PRODUCT/PROCESS CHANGE NOTICE (PCN)

| PCN #: TB-0609-02 DATE: 06-Oct-2006 Product Affected: SOJ 28L, 32L, 36L Products shipped in tube Date Effective: 06-Jan-2007 | MEANS OF DISTINGUISHING CHANGED DEVICES: <input type="checkbox"/> Product Mark <input type="checkbox"/> Back Mark <input type="checkbox"/> Date Code <input checked="" type="checkbox"/> Other Rev. 08 printed on shipping tube |

ATTACHMENT I - PCN #: TB-0609-02

| TITLE: PB/PBG 28/32/36 SHIPPING TUBE | | DRAWING NO. P1-069-000 MSC-3026 | | REV B | |

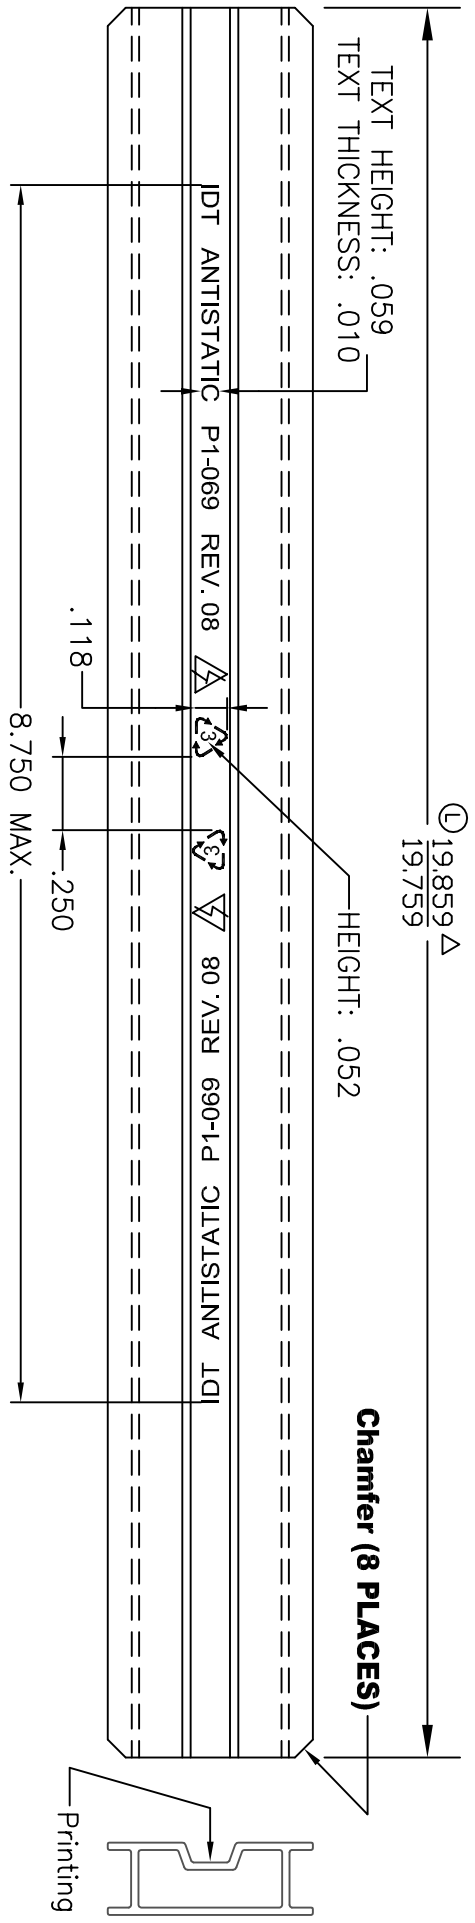
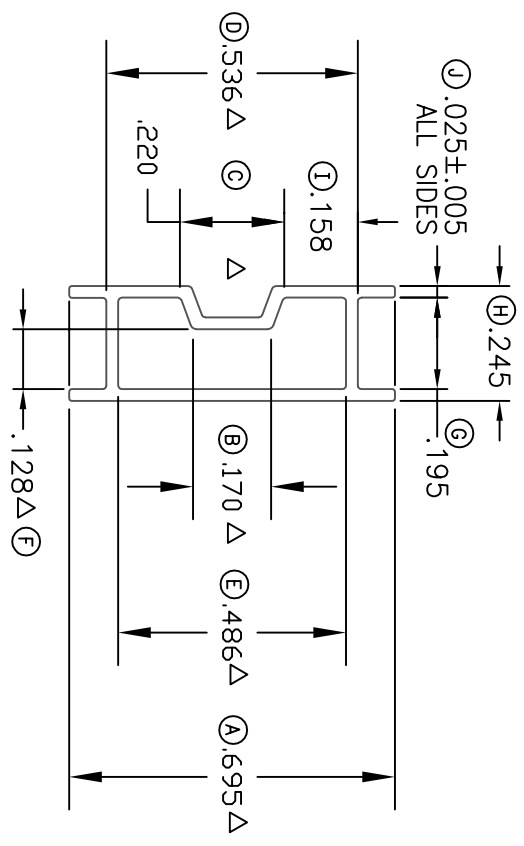
Detail of Change: This notification is to advise our customer that IDT has qualified new shipping tubes for SOJ 28L, 32L, 36L products. The new shipping tubes have an increase in the tube opening height from 0.105 inches to 0.128 inches to provide better protection for packages during assembly, test and backend processes.

| Description | Existing Shipping Tube | New Shipping Tube |
|--------------------------------|------------------------|-------------------|
| * Tube Opening Height (inches) | 0.105 | 0.128 |

* Note: Tube opening height is denoted as dimension 'F' in the tube drawing. See attachment for the drawing.

| REVISIONS | | | |
|-----------|------------------------------------|----------|----------|
| 14 | INCREASE (F) FROM 0.105" TO 0.128" | 08/24/06 | KK Three |
